PERMITTED DESIGN

PERMIT REVISION

LEVEL 10

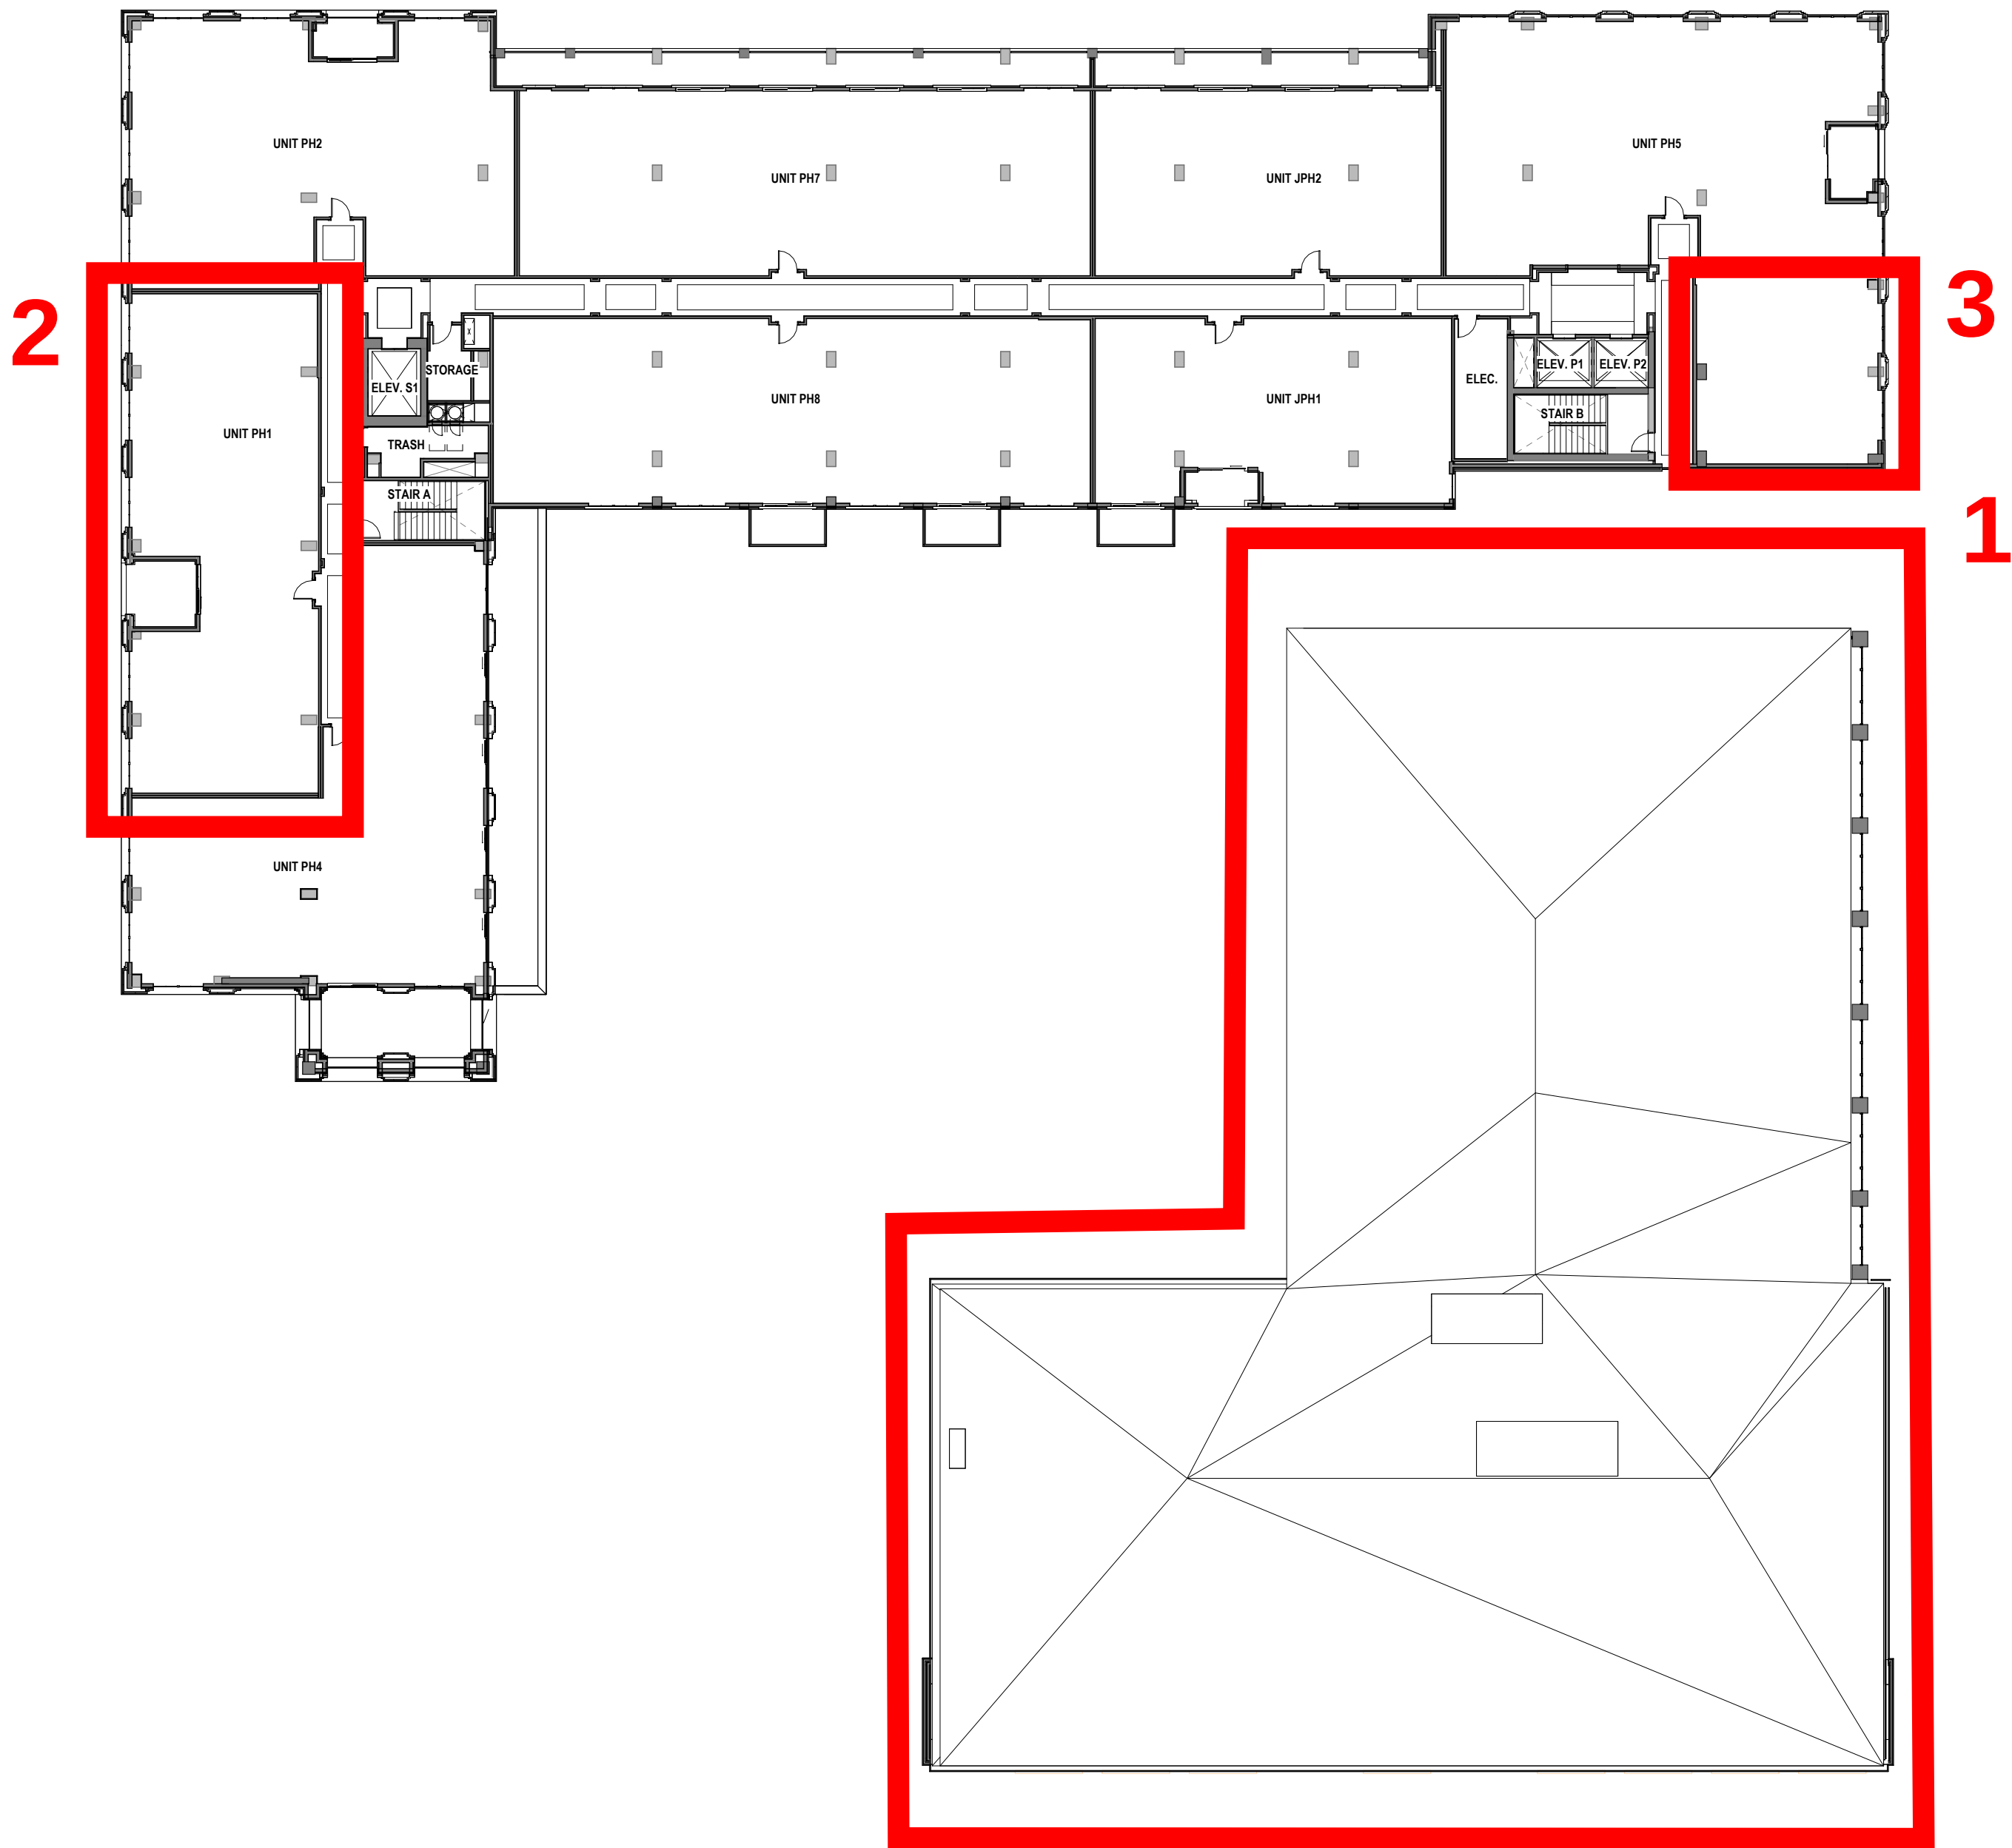
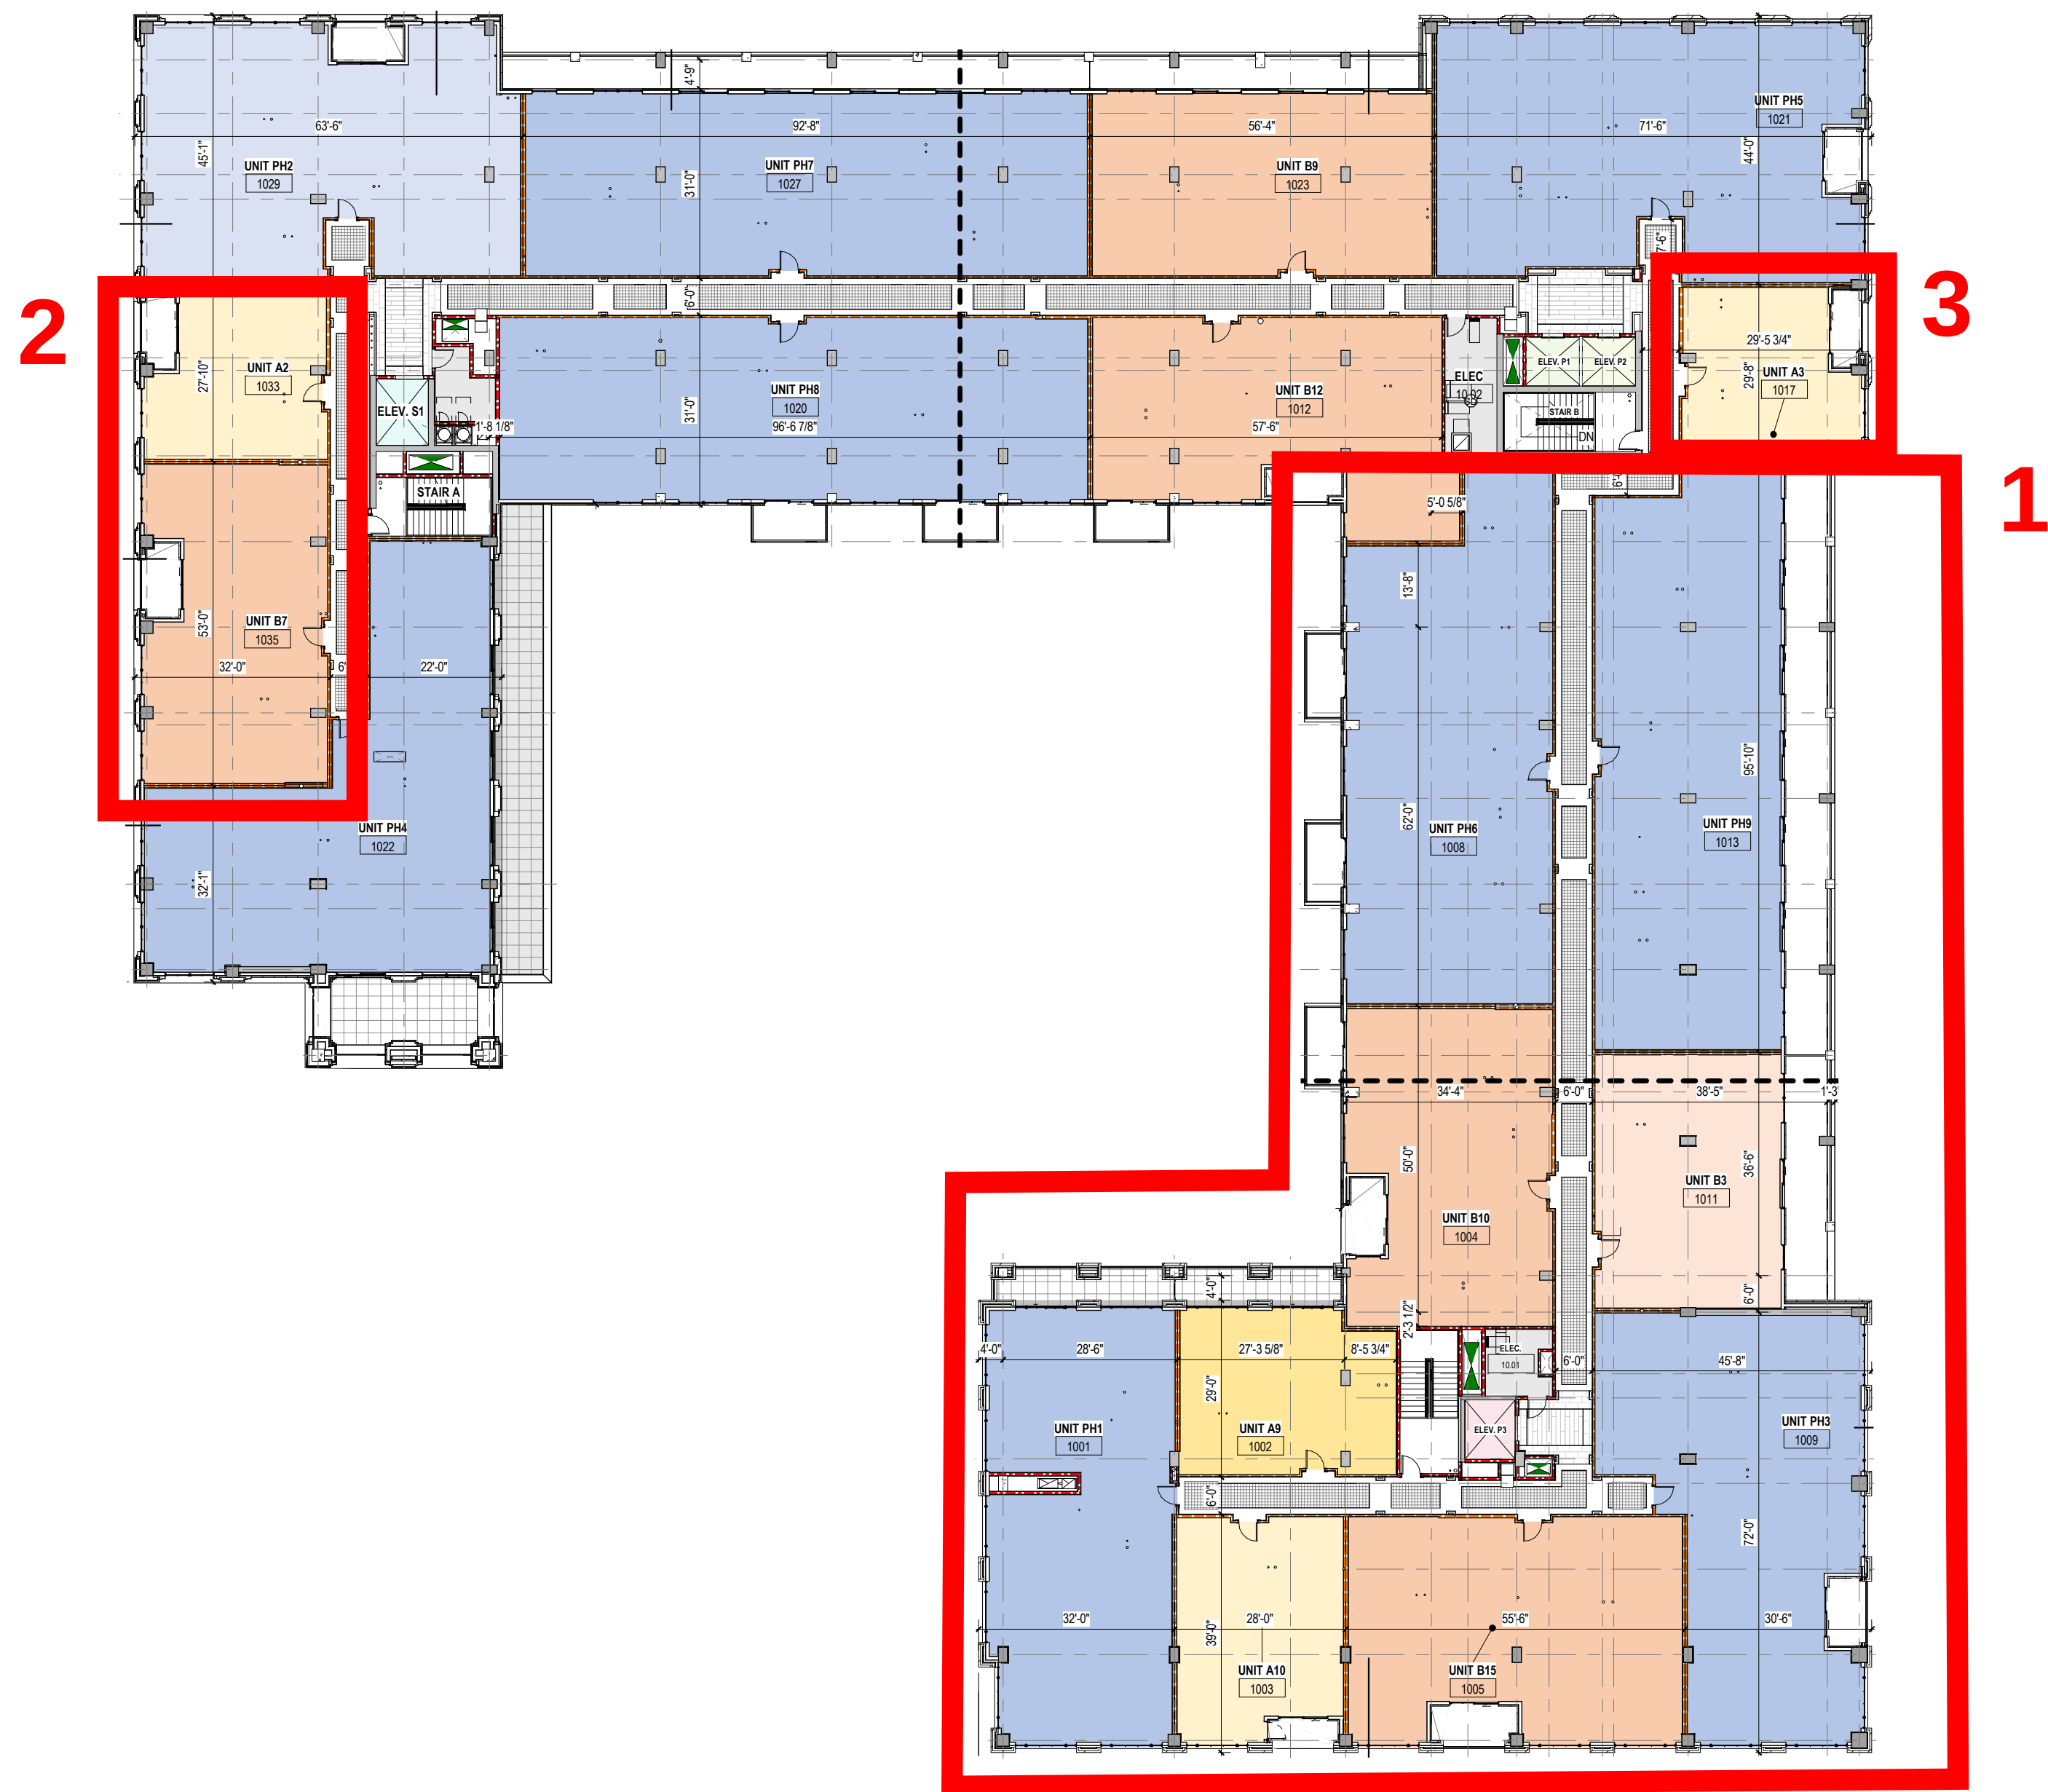
REVISIONS:

- 1. Apartment units removed. Level 10 is the office roof.
- 2. Units combined into one.
- 3. Unit absorbed into adjacent unit.
